Independent Technical Review of the C-400 Interim Remedial Project Phase I Results, Paducah, Kentucky

Prepared by: The DOE EM Center for Sustainable Groundwater and Soil Solutions,
Savannah River National Laboratory, Aiken SC

October 2010

Figure 2. Phase I C-400 thermal treatment site layout and examples of “steady state” temperature maps for the UCRS and deep RGA (data are from the ERH project data portal)

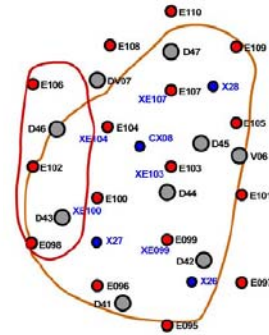
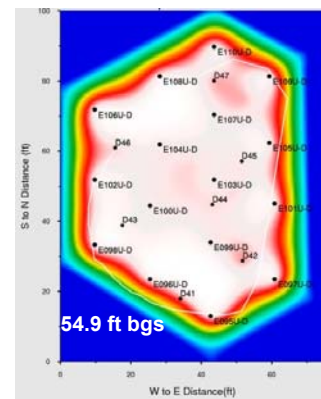
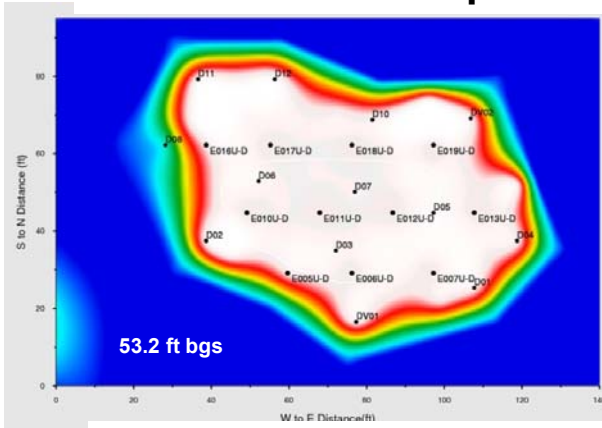
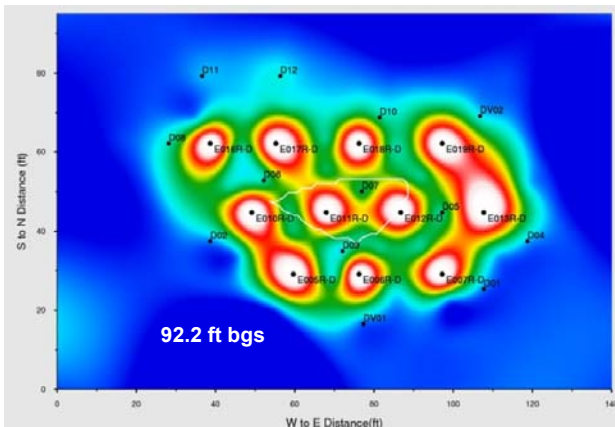
Note that the contour plot for temperatures in the deep RGA almost certainly overstates the size of the hot areas around the electrodes because there are insufficient numbers of digiTAMs to control for the cool temperatures occurring between the various pairs of adjacent electrodes – everywhere there is a digiTAM between electrodes, the picture cools to green while areas without such control allow the warm colors to coalesce. Further, the extent of the warmest (white and pink) areas around the electrodes is not substantiated by data (these areas were not monitored) and the depiction is a function of the contouring algorithms that may not represent actual conditions. Despite these standard limitations associated with machine contouring (a necessity to allow posting and rapid sharing the data on the project portal), the images provide a generally accurate broad conceptual picture of RGA heating performance. The plots clearly indicate that heating in the lower portion of the RGA was ineffective – with target temperatures extending less than 5 radial feet from the electrodes. The uppermost 3 to 6 feet of the RGA (layer map not shown in Figure 2) exhibited more uniform heat suggesting that the localized heating around the electrodes in the this permeable aquifer resulted in upward convection of hot water and steam and lateral spread at the RGA UCRS interface. These heat distributions and patterns are fundamental to the conditions of the RGA and are consistent with the 2007 ITR predictions and comments (Looney et al., 2007).

Figure 4. Response of downgradient RGA wells to Phase I ERH operation. The Phase I heating locations are marked in red and the data for TCE concentration as a function of time are shown for each elevation in each well.

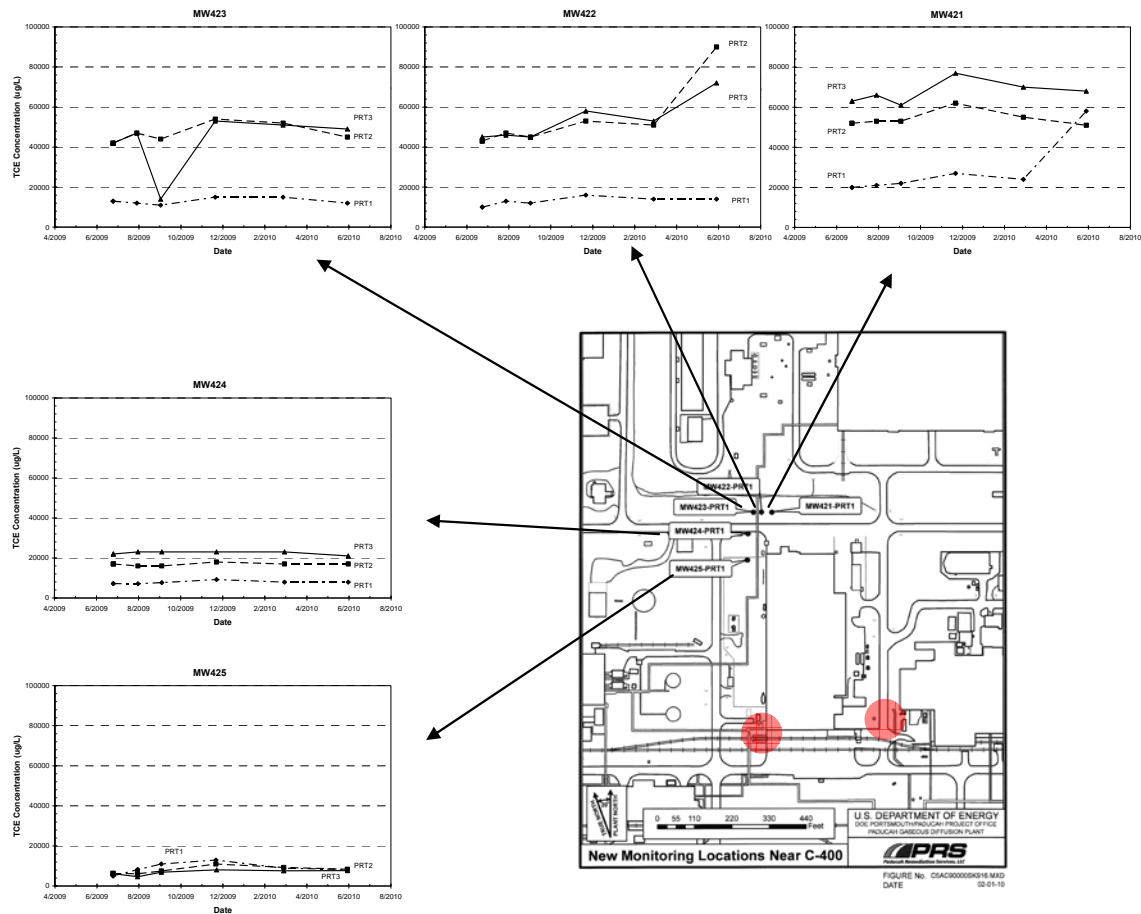
Groundwater would be expected to flow from the heated areas toward monitoring well locations 421-425. Each of these wells is completed as a cluster with PRT1 installed in the upper RGA and PRT2 and PRT3 installed progressively deeper in the aquifer. Based on the elevated concentrations prior to heating, Figure 4 suggests that MW421, MW422 and MW 423 are strongly impacted by the C-400 Building TCE source zones while MW424 and MW 425 exhibit somewhat lower concentrations. The most notable early observations following Phase I heating are: a) the deepest screen zones in MW422 appear to be increasing and b) the shallowest screen in MW 421 appears to be increasing. These data may indicate measurable TCE migration (MW422) and/or vertical blending of the upgradient TCE source in the RGA during thermal treatment (e.g., MW 421). Based on the measurements of groundwater trends within the treatment zone, concentrations in down gradient wells might be expected to reverse and trend downward at some point in the near future. The ITR recommends continued evaluation of the response of these and

other downgradient wells as important indicators of the performance of the thermal remediation toward the important-overarching ROD goals “to remove a significant portion of the VOCs from the subsurface in the vicinity of the C-400 Cleaning Building ... and to reduce the period of time that TCE contaminates groundwater.”
